Draft EIS Public
Comments

RE: Draft Environmental Statement (EIS) for the TA-7 Recapitalization at Laughlin Air Force Base (AFB)

Re: **TCEQ NEPA Request #2024-037. LAUGHLIN AFB T-7A RECAPITALIZATION EIS. Val Verde County.**

Subject: Recapitalization with T-7A Red Hawk aircraft and flight operations at Laughlin Air Force Base, Texas

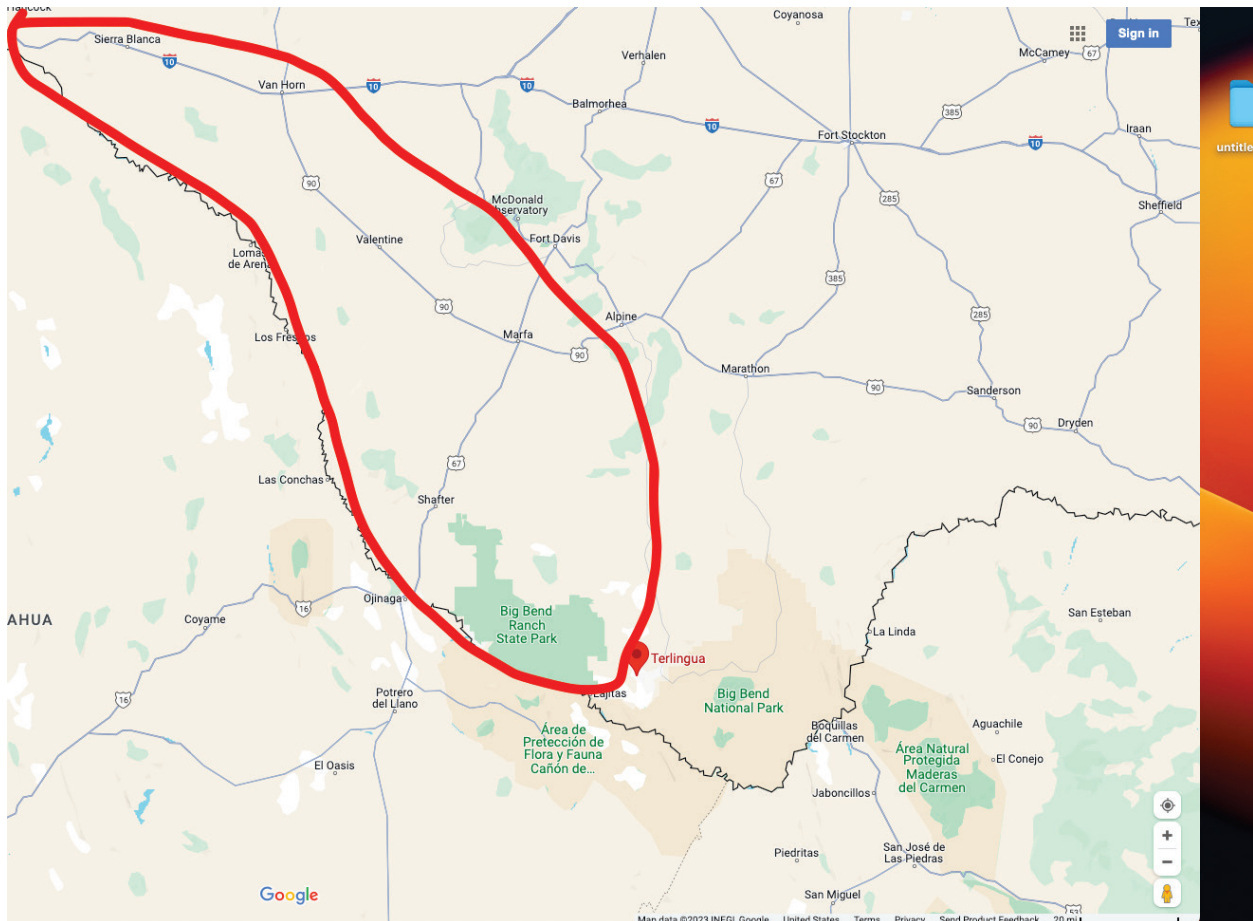
1) Referring to attached screenshot, are there currently any overnight training in the areas in the area circled in red? This is the area that is west of Big Bend National Park, South of Fort Davis, and east of Fort Hancock.

2) As far as the proposal draft EIS, will there be any overnight training above Big Bend National Park?

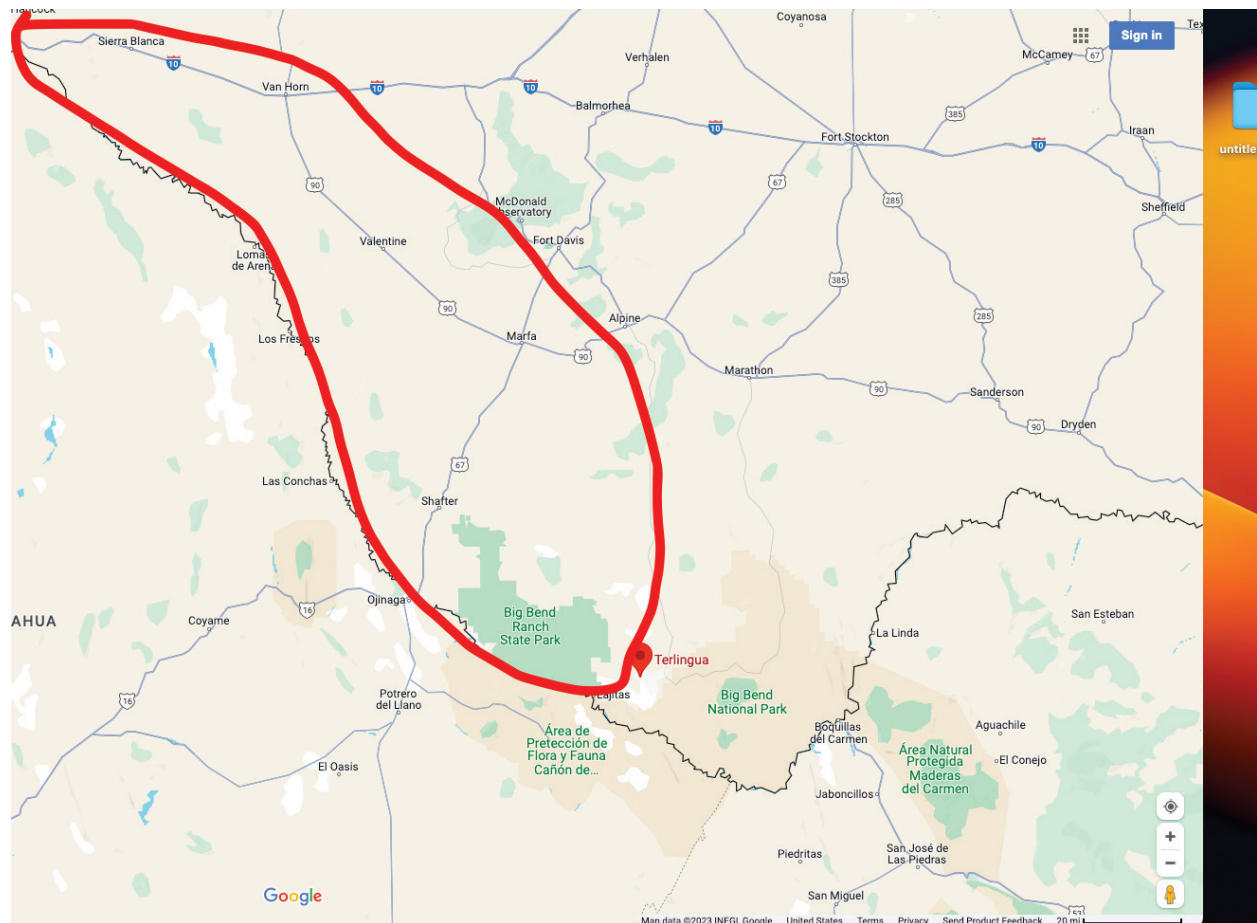
1) Referring to attached screenshot, are there currently any overnight training in the areas in the area circled in red? This is the area that is west of Big Bend National Park, South of Fort Davis, and east of Fort Hancock.

2) As far as the proposal draft EIS, will there be any overnight training above Big Bend National Park?

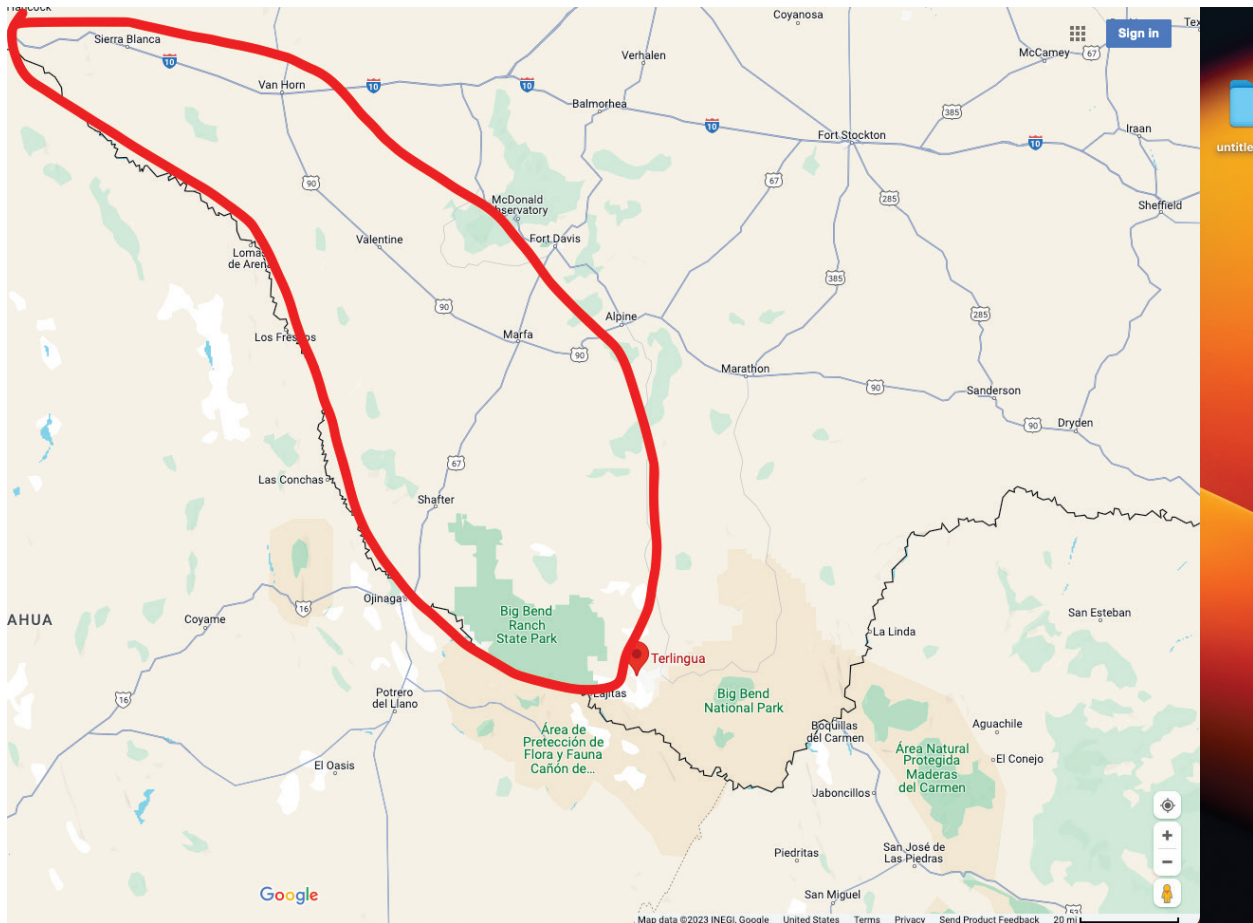
1) Referring to attached screenshot, are there currently any overnight training in the areas in the area circled in red? This is the area that is west of Big Bend National Park, South of Fort Davis, and east of Fort Hancock.

2) As far as the proposal draft EIS, will there be any overnight training above Big Bend National Park?
